DRAINAGE IMPACT ASSESSMENT REPORT

PROPOSED TEMPORARY WAREHOUSE (STORAGE OF CONSTRUCTION MATERIALS, METAL AND ELECTRONIC PARTS) AND OPEN STORAGE OF CONSTRUCTION MATERIALS FOR A PERIOD OF 3 YEARS

Report no. SDP/HT/001A

Response to DSD's comment on 31st July 2024

SECTION B-B

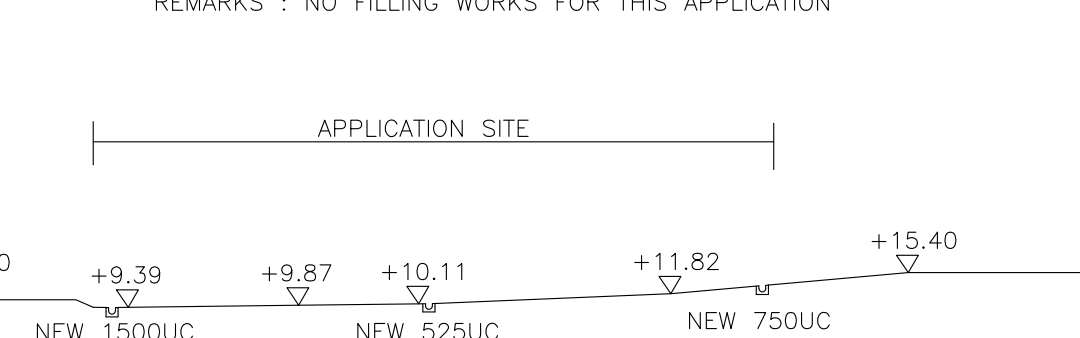
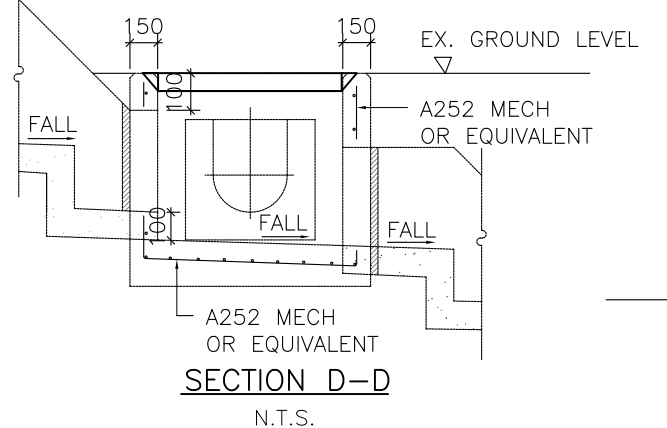
4	Further to (3) above, since there is no record of the said box culvert, please provide site photos to demonstrate its presence and existing condition.	The photo of the existing box culvert is appended in Appendix C of DIA report in this resubmission.
5	Cross sections showing the existing and <u>proposed</u> ground levels of the application site with respect to the adjacent areas should be given.	It is noted that no filling and excavation works would be carried out in the application site. Cross sections showing the existing ground levels of the application site with respect to the adjacent areas are provided on the drainage plan in this resubmission.
6	Where walls or hoardings are erected/laid along the site boundary, adequate opening should be provided to intercept the existing overland flow passing through the site.	100mm opening at 1m c/c at the bottom of walls or hoarding if any would be provided and indicated on general notes of drainage plan in this resubmission.

REMARKS : NO FILLING WORKS FOR THIS APPLICATION

CATCHMENT AREA PLAN FOR A1 AND A2

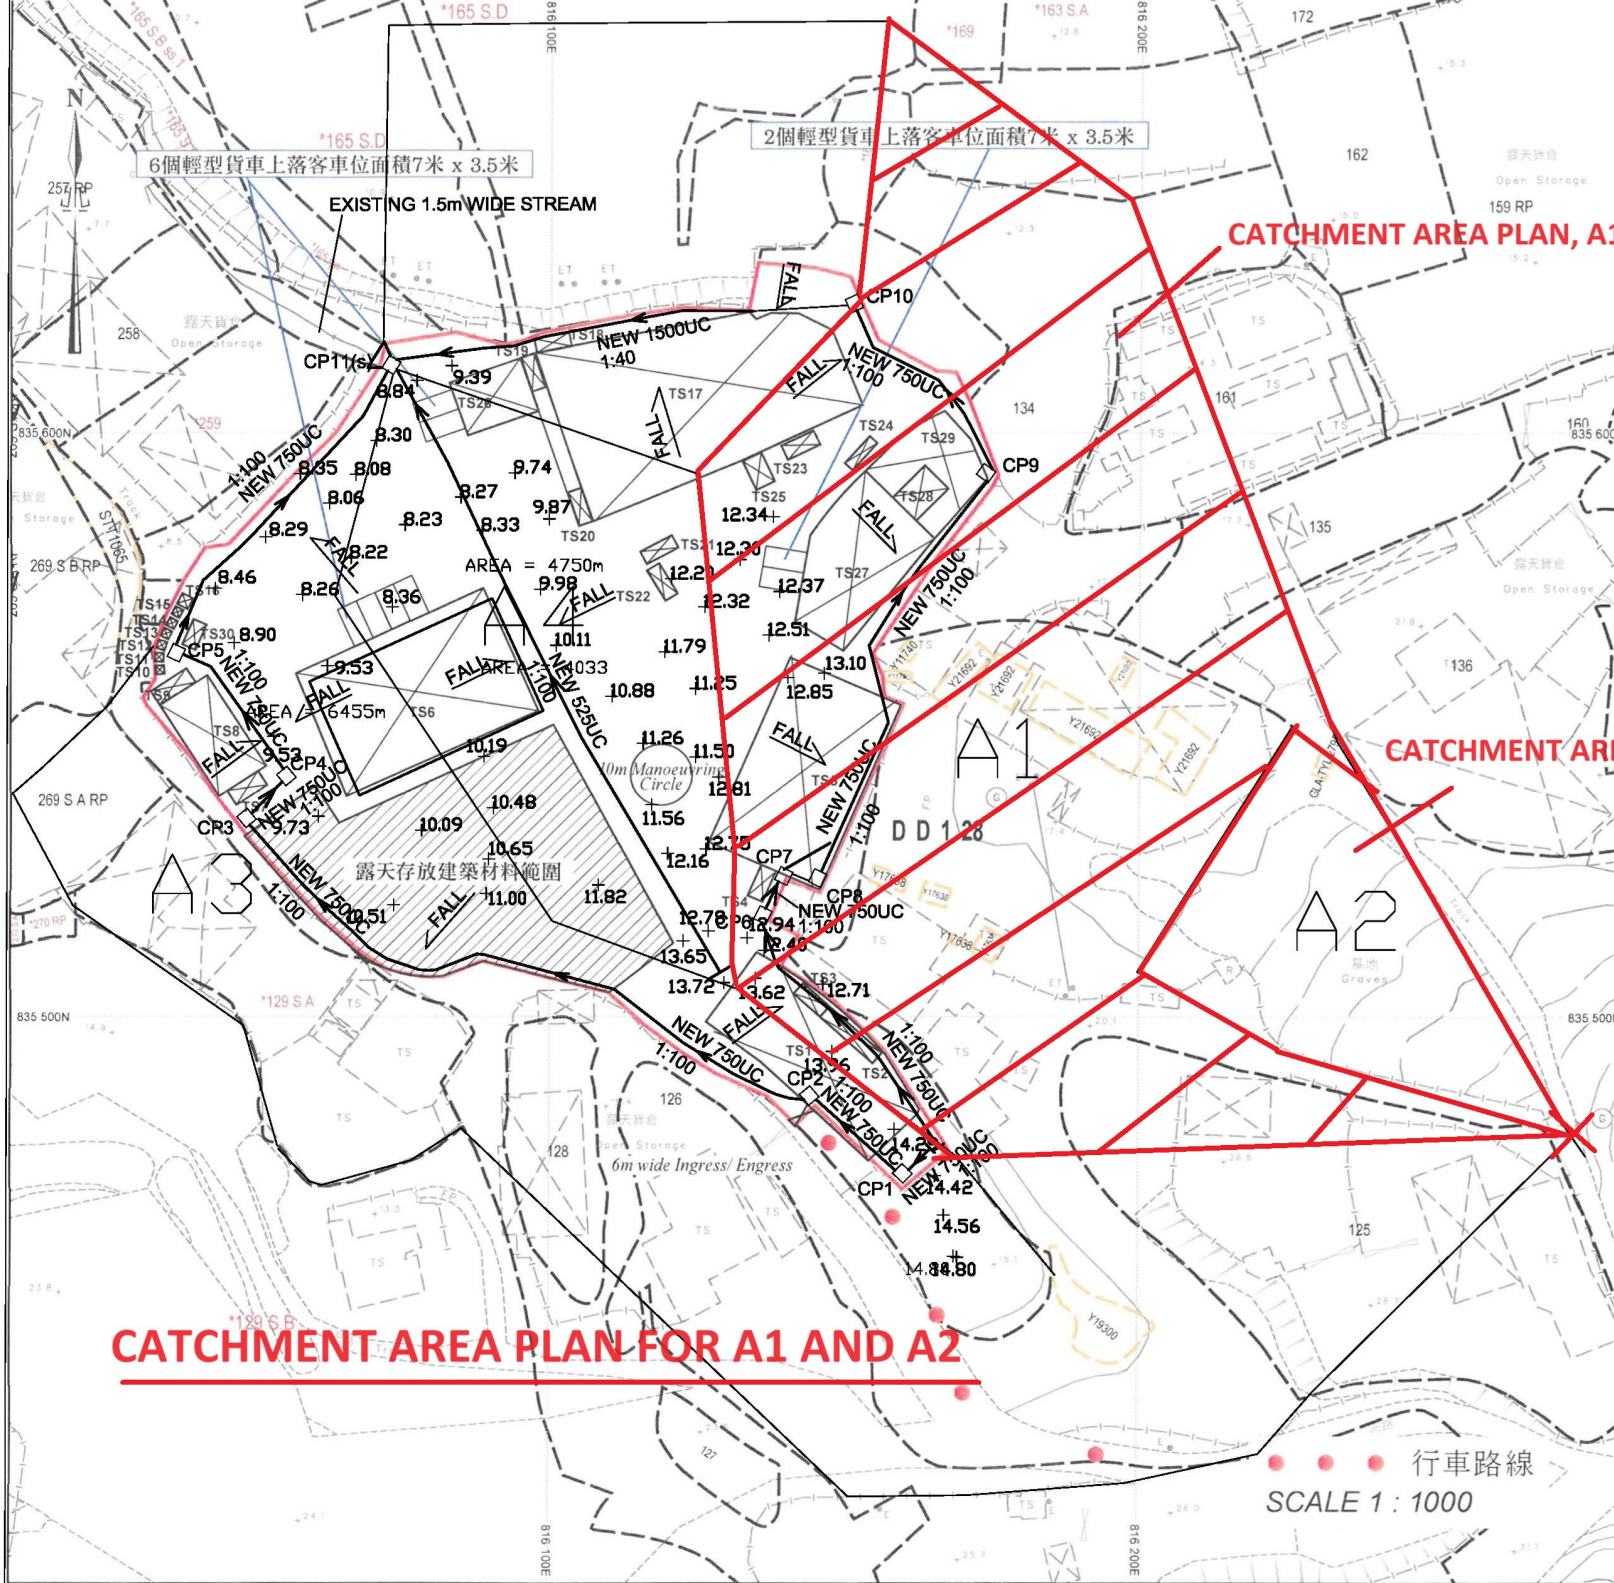
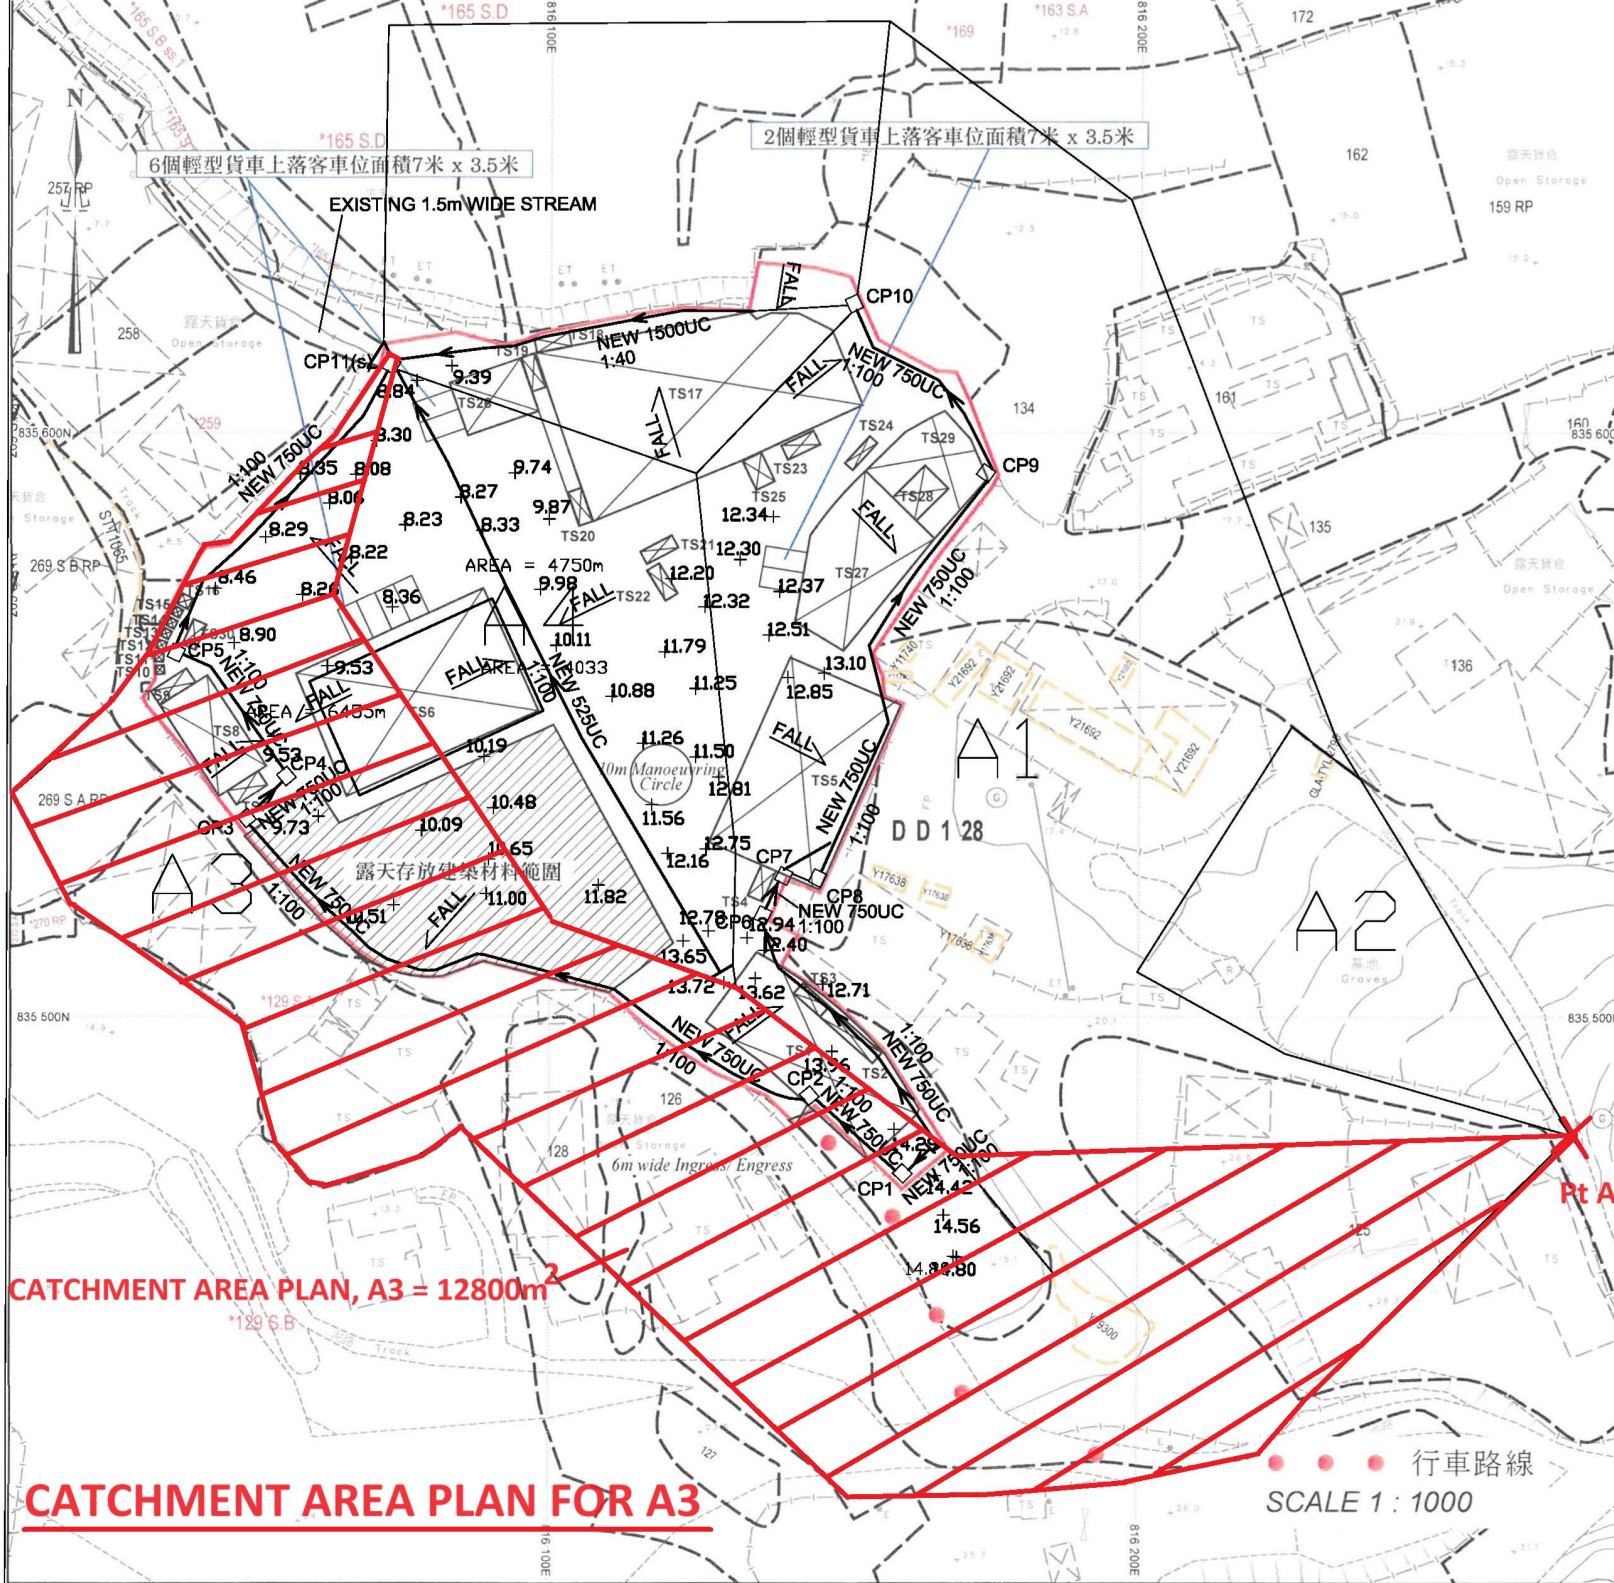
Item	DSD's comment	Response to comment
1	<p>The ground to the east/south/north of the application site is generally/significantly higher. Since the overland flow from adjacent lands shall be probably intercepted, external catchment shall be considered in the calculation. Please justify the extent of the external catchment included in the DIA.</p>	<p>The catchment area for the overland flow intercepted from adjacent lands is considered in the calculation in this resubmission.</p>
2	<p>The existing stream for discharge of the runoff from the application site is not maintained by DSD. The applicant shall resolve any conflict/disagreement arisen from discharging the runoff from the application site to the proposed discharge point(s). Moreover, the applicant should ensure that this drainage system and the existing downstream drains/channels/streams have adequate capacity to convey the additional runoff from the application site. Regular Maintenance including the existing stream should be carried out by the applicant to avoid blockage of the system. In the case that it is a local village drains, District Officer (Yuen Long) should be consulted.</p>	<p>Noted.</p>

Catchment area,	A1	=	12696	m ²	Assume k = 1.0 for paved surface
	A2	=	2436	m ²	Assume k = 0.3 for unpaved surface
	Total Area, A	=	16696 + 0.3x2436		
		=	13426.8	m ²

Longest distance from summit point to outlet, CP10 (Ld) = 310.00 m
 Shortest distance from summit point to outlet, CP10 (Ls) = 183.00 m

(Existing 1.5m width and 1.1m depth Box Culvert)

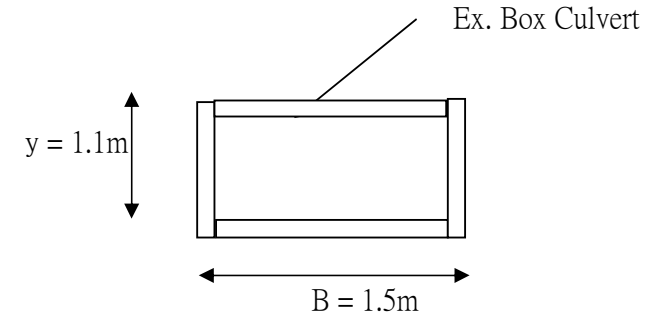
3	<p>The existing stream will discharge to a box culvert (not maintained by DSD). Please demonstrate with hydraulic calculation that the existing box culvert is adequate to collect, convey and discharge the surface runoff accrued on the application site and the overland flow intercepted from adjacent lands.</p>	<p>The hydraulic calculation of the existing box culvert is carried out and found adequate to collect and discharge the surface runoff accrued on the application site and the overland flow intercepted from adjacent lands.</p>

$$Q = 402226 \quad \text{lit/min} \quad > 165495 \text{ lit/min}$$
